DEPARTURE REQUESTS

DEPARTURE EXHIBITS

D1 -- Departure Request

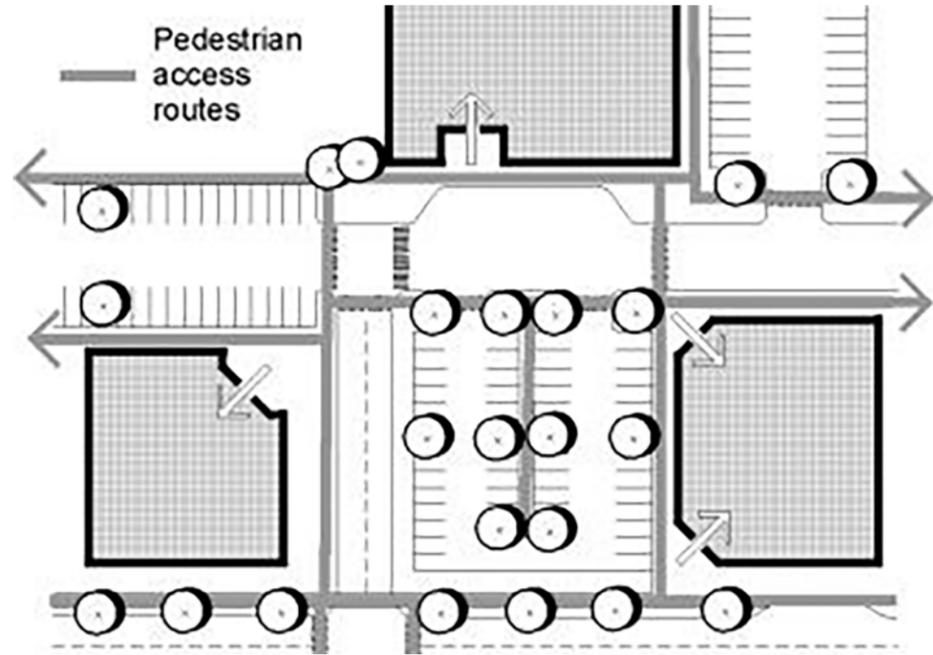
#	Land Use Code	Code Item	Code Requirement	Departure Request	Design Rationale
Site Development Standards					
Departures related to site design dimensional requirements					
D1	20.50.240.C.1.e	Site Design - Site Frontage	A building's primary entry shall be located on a street frontage and recessed to prevent door swings over sidewalks, or an entry to an interior plaza or courtyard from which building entries are accessible;	Allow for building entries along Westminster Way and N 160th Street to be accessed from an internal public open space with a pedestrian connection to the public right of way.	Significant grade changes along both Westminster Way and N160th do not allow for all primary building entries to be located on the street frontage. Where physically feasible, building entries are located near site entry drives and connected to the public right-of-way by an accessible pathway through a public open space. Primary entries indicated in red and clouded on Departure Exhibit D1

D3 --- Departure Request

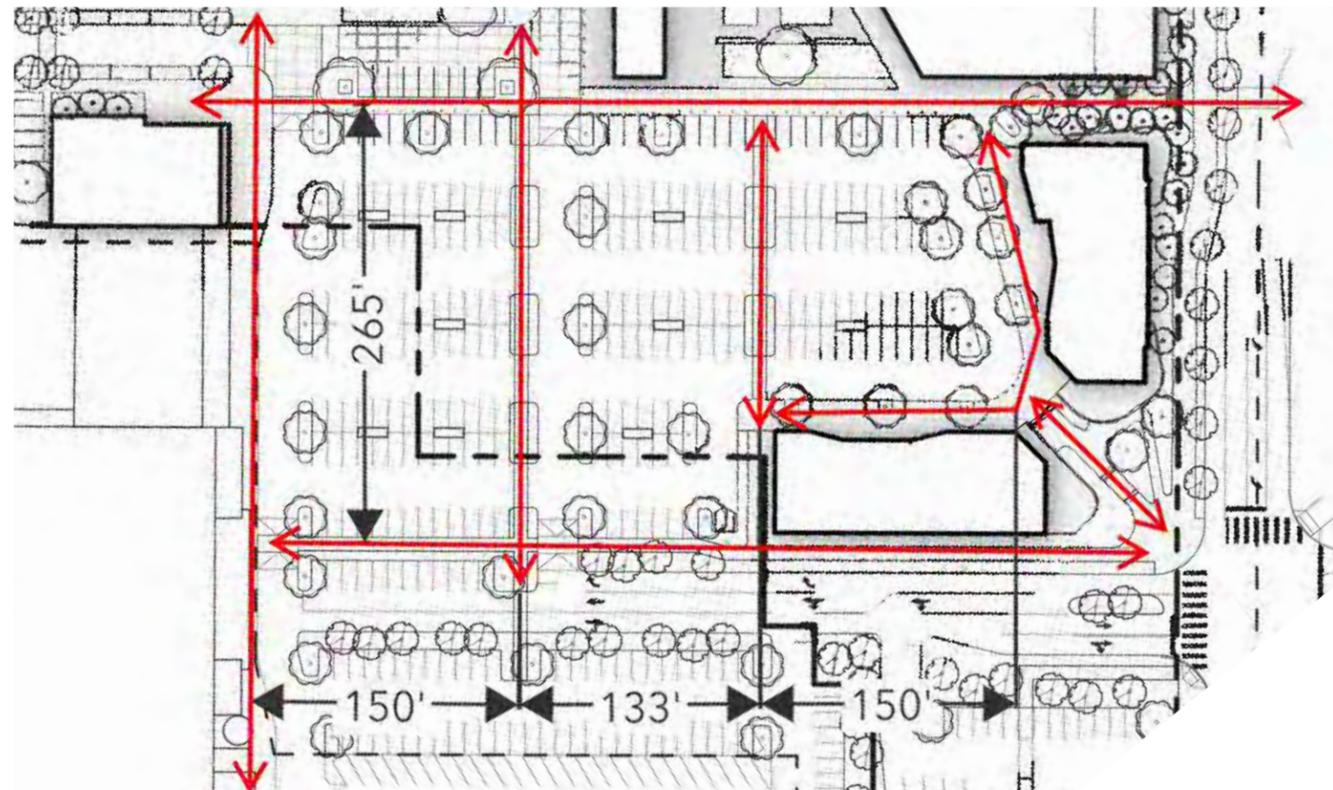
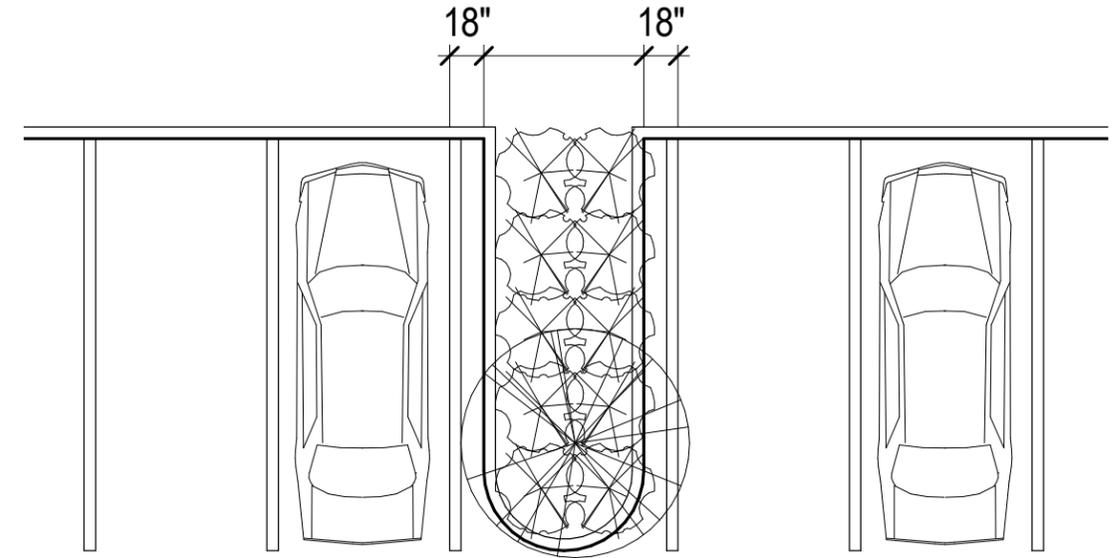
D2	20.50.240.E.1.a	Site Design - Internal Site Walkways	All development shall provide clear and illuminated pathways between the main building entrance and a public sidewalk. Pathways shall be separated from motor vehicles or raised six inches and be at least 8 feet wide	Allow for sidewalks along private residential streets and pathways not serving commercial uses to be reduced to 6 feet wide.	A 6' wide sidewalk along private residential streets with no commercial frontage would exceed the minimum 5feet wide sidewalk as required per. section 12.8 (Private Streets) of the Shoreline Engineering Manual.
D3	20.50.240.E.1.c	Site Design - Internal Site Walkways	Raised walkways at least eight feet wide shall be provided for every three, double-loaded aisles or every 200 feet of parking area width. Walkway crossings shall be raised a minimum three inches above drive surfaces	Allow for walkways to be provided for every 265 feet of parking lot width provided that no parking stalls is more than 100 feet from a walkway,	A parking lot with three code compliant double-loaded aisles exceed the minimum 200 feet aisle separation. The proposed site design creates a framework of well connected pedestrian scaled blocks that serves uses on multiple sides. The largest proposed distance between walkways is greater than 200 feet, however no stall is more than 100 feet from a walkway which is consistent with the intent of the code requirements. Proposed Departure supported by Departure Exhibit D3

D4 --- Departure Request

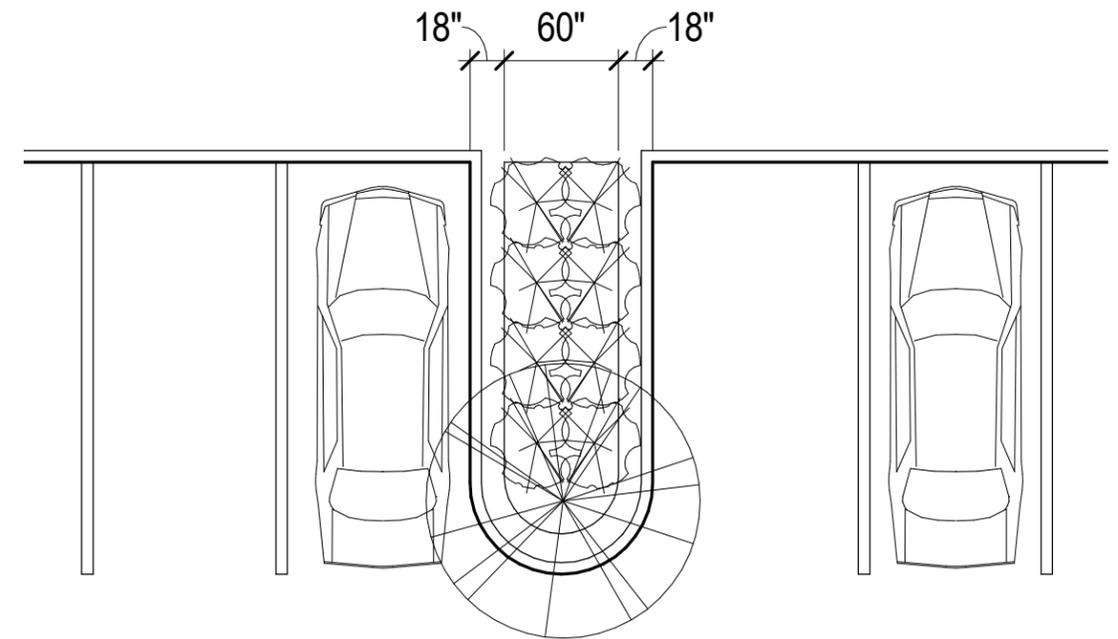
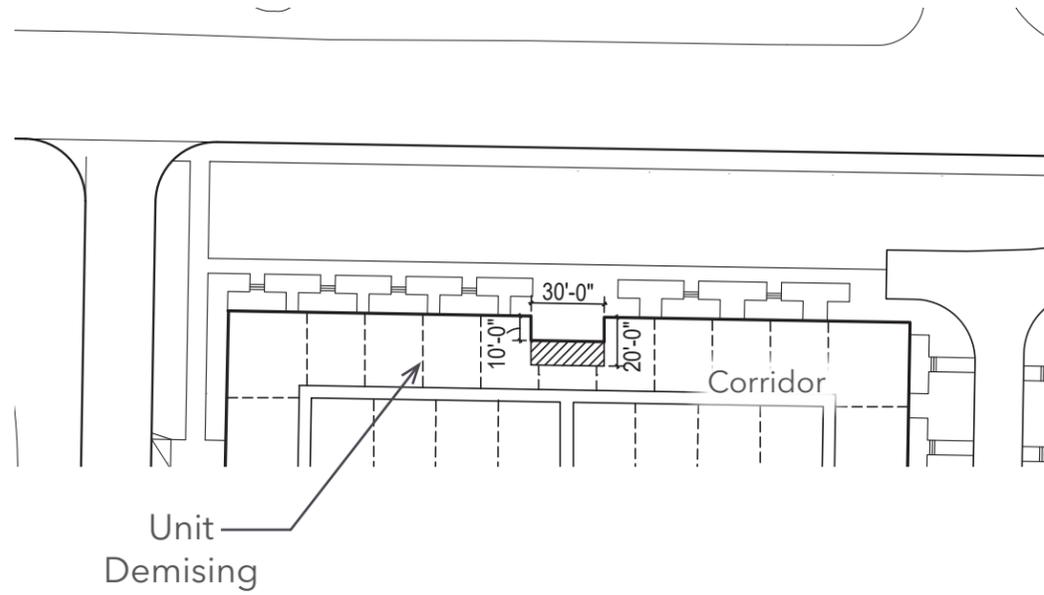
D4	20.50.410.H	Parking design standards	Parking spaces abutting a landscaped area on the shall provide an additional 18 inches to provide a place to step other than in the landscaped area. In a parking garage, any space abutting a wall shall provide an additional 18 inches.	Allow for the required 18" step-off to be provided with a 12" paving strip inside the 6" curb.	This departure would still achieve the goal of not requiring a driver or passenger to step into a landscape area, but onto a durable surface. This is the same condition that occurs at parallel street parking. Proposed Departure supported by Departure Exhibit D4
D5	20.50.410.F	Parking design standards	Stall size (width x length) to be: <ul style="list-style-type: none"> Desired: 9' x 20' Minimum: 8.5' x 20' Compact: 8' x 16' Note: up to 50% of stalls allowed to be compact stalls	Allow for the following stall sizes (width x length): <ul style="list-style-type: none"> Desired: 9' x 18' Minimum: 8' x 16' Compact: 7.5' x 15' Note: up to 50% of stalls allowed to be compact stalls	The site design recognizes that transient users require larger parking stalls due to the higher turn-over rate. With this in mind, the site plan includes a combination of 9'x 20' and 9' x 18' commercial stalls with a less than 25% of stalls being 9' x17'. Smaller stall sizes, specifically within residential buildings are more consistent with the urban character of the development and the goal of increasing land efficiency as outlined in the CRA.

D8 --- Departure Request --- Plan

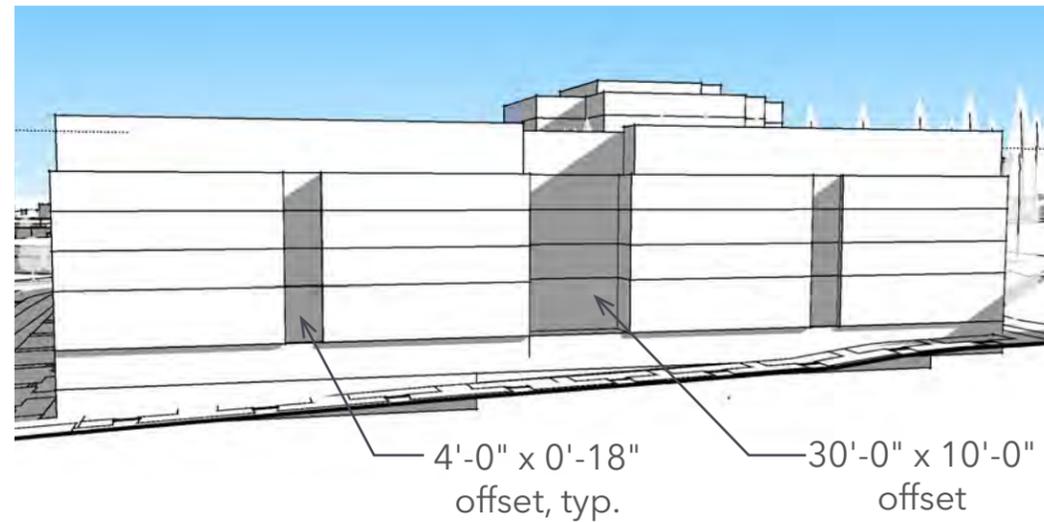
D8	20.50.250.B.5	Building Design - Building Articulation	<p>Every 150 feet in building length along the street front shall have a minimum 30-foot-wide section that is offset by at least 20 feet through all floors.</p>	<p>Every 150 feet in building length along the street front shall have a minimum 30-foot-wide section that is offset by at least 10 feet through all floors above the ground level floor.</p>	<p>Extending the required building articulation down to the ground level interrupts the consistency of the urban street frontage. A departure from this requirement would enhance the ground level experience as envisioned in the Aurora Square CRA.</p> <p>Proposed Departure supported by Departure Exhibit D8</p>
